ADA Curb Ramp New Construction Inspection Form (Parallel)

23885.56			
North-South Road Name	Project No.	Sheet No.	Intersection No.	East-West Road Name

PARALLEL RAMP (PL)

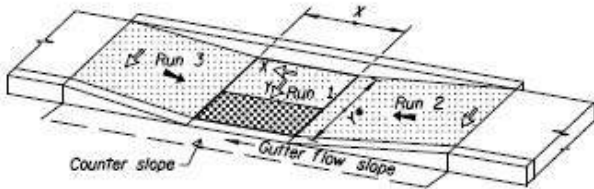
RAMP RUN 3	Pass	Fail
Running Slope 3	<input type="text" value="9.2"/> ≤ 8.3% <input type="checkbox"/> > 8.3% <input checked="" type="checkbox"/>	
Length 3	<input type="text" value="7.5"/>	
Cross Slope 3	<input type="text" value=""/> ≤ 2.0% <input type="checkbox"/> > 2.0% <input type="checkbox"/>

DWS IITD Fails turn space, RR to nowhere
